STATE OF DELAWARE
EXECUTIVE DEPARTMENT
OFFICE OF
STATE PLANNING COORDINATION

RE: PLUS 2005-06-11, Smyrna School District Additions

Map of Smyrna School Expansions showing excellent recharge in green, wellhead areas in red and the sites impacted in light blue.

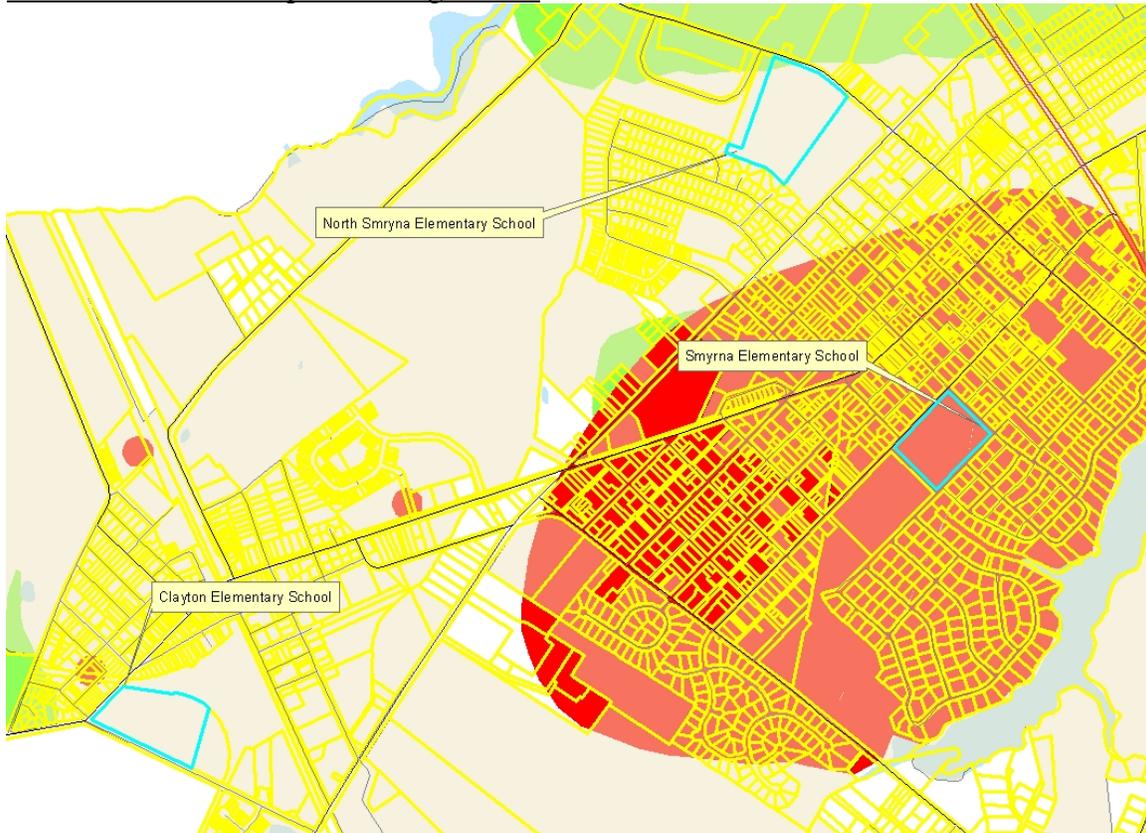
The DNREC Water Supply Section has reviewed the above referenced PLUS project and determined that each site has its own unique characteristics. The Clayton Elementary School addition does not impact an excellent recharge area or wellhead area. The North Smyrna Elementary School addition impacts an excellent recharge area. The Smyrna Elementary School is entirely within the wellhead protection area for Smyrna Water.

The DNREC Water Supply Section recommends that that portion of the new development within the excellent recharge area not exceed 20% impervious cover. The Smyrna Elementary School impervious cover is proposed to change from 30% to 33%. The North Smyrna Elementary School impervious cover is proposed to change from 20% to 26%. The current levels of impervious cover are at the threshold values for augmenting ground-water recharge.

The North Smyrna Elementary School expansion building does not directly overlay the excellent recharge area. The impact to the excellent recharge area in increasing the impervious cover should be negligible.

Due to the increase in impervious cover at the Smyrna Elementary School expansion, some allowance for augmenting ground-water recharge should be considered since the impervious cover exceeds 20% in the wellhead area but is still less than 50% of that portion of the parcel within this area. The purpose of an impervious cover threshold is to minimize loss of recharge (and associated increases in storm water) and protect the quality and quantity of ground water and surface water supplies. This can be achieved by using a rooftop runoff system for each of the structures constructed.

Engineered roof-top run-off systems can achieve results that preserve similar characteristics to the current state of recharge and protection without redoing the plan.
